Product Change Notification - ASER-18GLCT091

CCB 4193 Final Notice: Qualification of MTAI as a new final test site for selected SST25VF016B-50xxx products available in 8L SOIJ (5.4x5.4x2.16mm) package.

CCB 4193

March 18, 2020

PRE AND POST CHANGE

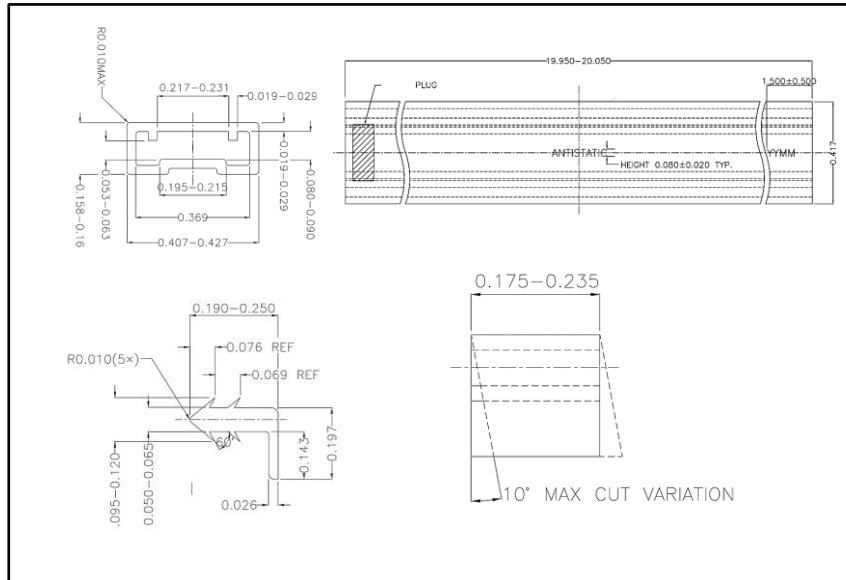
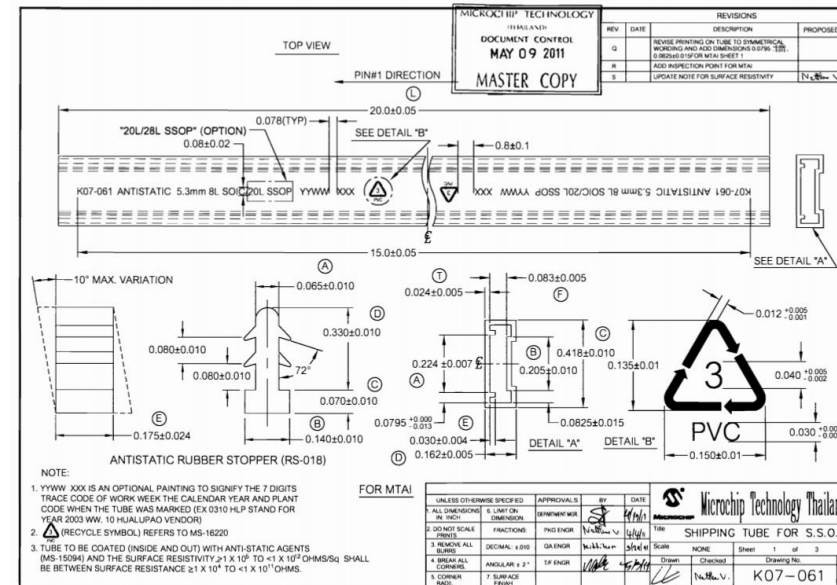
Tube Length	Dimension	Color
20.00 +/-0.05 inch	See on drawing	Clear

Tube Length	Dimension	Color
20.00 +/-0.05 inch	See on drawing	Clear

PRE AND POST CHANGE

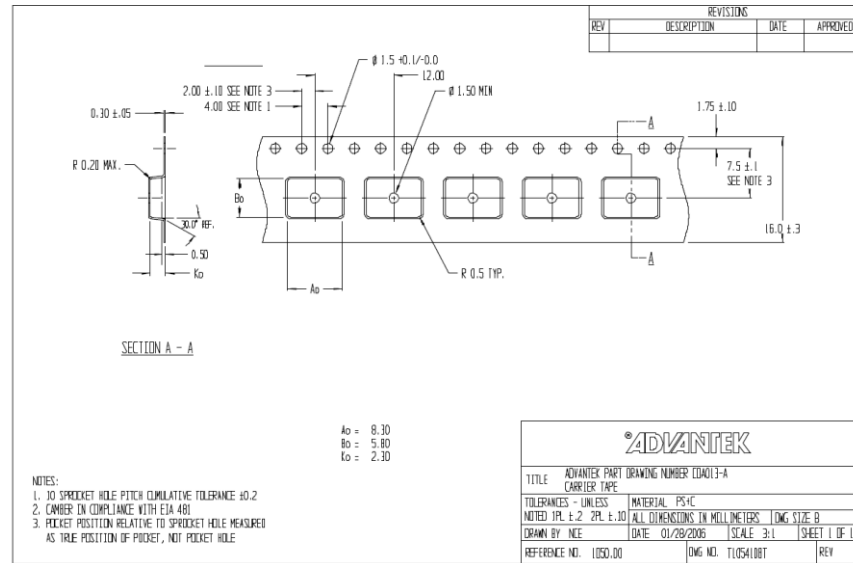
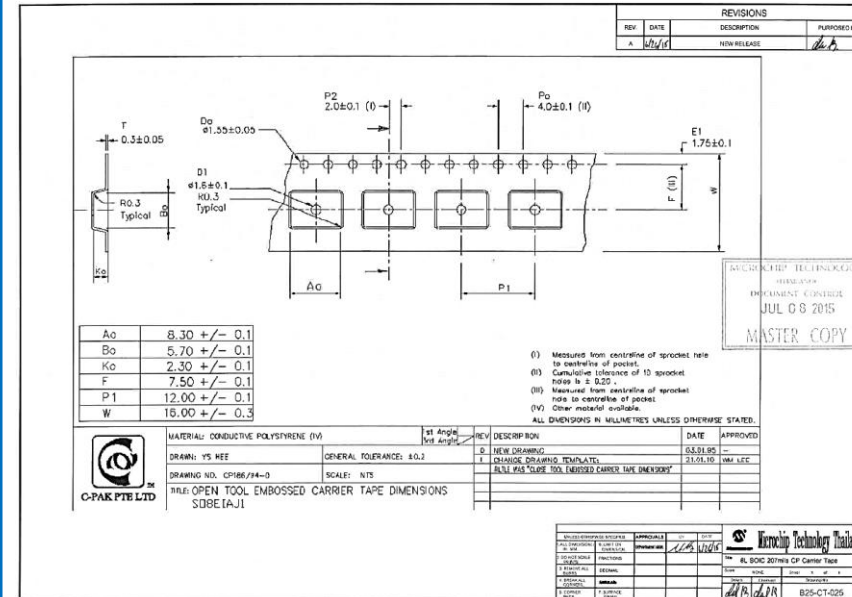
Supplier	Mfg. Part No.	W (mm.) ± 0.3 or Specific	P (mm.) ± 0.1 or Specific	$A_0 \pm 0.1$ or Specific	$B_0 \pm 0.1$ or Specific	$K_0 \pm 0.1$ or Specific	Thickne ss
Advantek	CDA013-AC410	16	12	8.30	5.80	2.30	0.30 +/- 0.05

Supplier	Mfg. Part No.	W (mm.) ± 0.3 or Specific	P (mm.) ± 0.1 or Specific	$A_0 \pm 0.1$ or Specific	$B_0 \pm 0.1$ or Specific	$K_0 \pm 0.1$ or Specific	Thickne ss
C-PAK	SO8EIAJ1 CL3 18x6CY L260 W16	16	12	8.30	5.70	2.30	0.30 +/- 0.05

PRE AND POST CHANGE

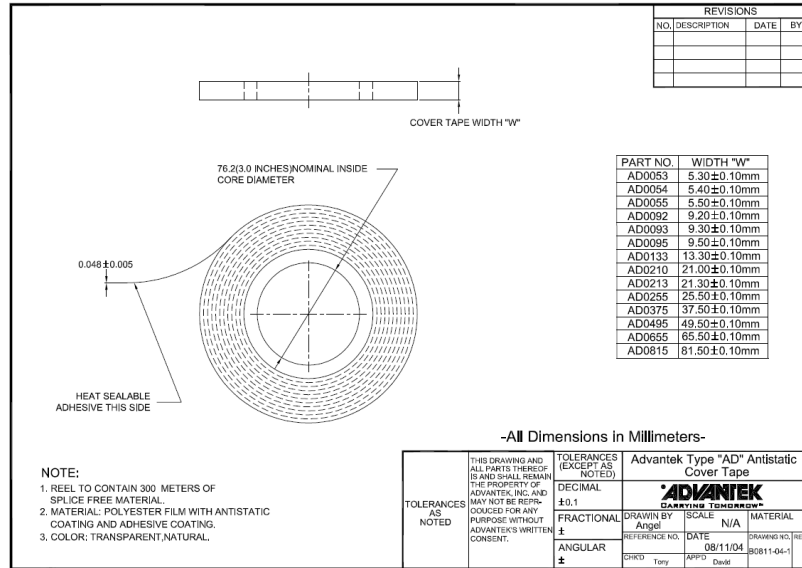
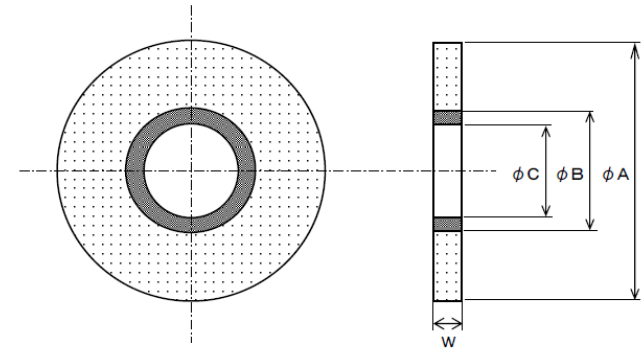
Carrier Width	Supplier	Supplier Part	Width "W" (mm)	Thickness (mm)	Sealing Mythology
16mm	Advantek	AD0133	13.30 +/- 0.10	0.048 ±0.005	Heat seal

Carrier Width	Supplier	Supplier Part	Width "W" (mm)	Thickness (mm)	Sealing Mythology
16mm	Sumitomo	CSL-Z7302	13.30 +/- 0.10	0.050 ±0.010	Heat seal

PRE AND POST CHANGE

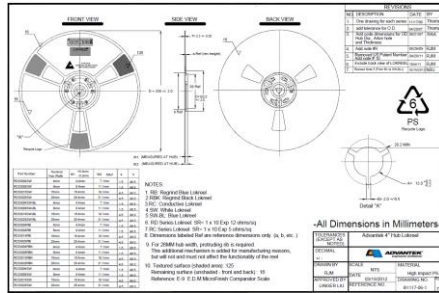
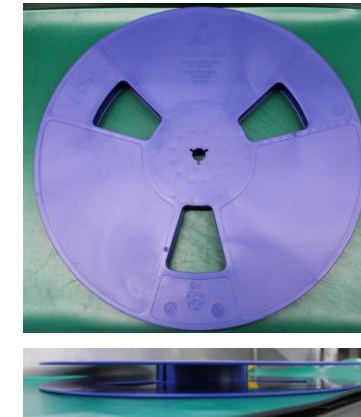
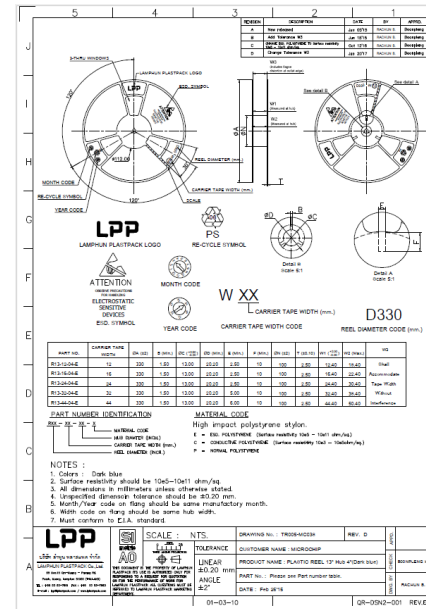
Width	Supplier	Diameter	Supplier Part	Hub	Color
16mm	Advantek	330mm +/- 2.0mm	R13-16-04-E	4inch (102 +/- 0.2mm)	Dark Blue

Width	Supplier	Diameter	Supplier Part	Hub	Color
16mm	LPP	330mm +/- 2.0mm	R13-16-04-E	4inch (100mm +/- 0.2mm)	Dark Blue
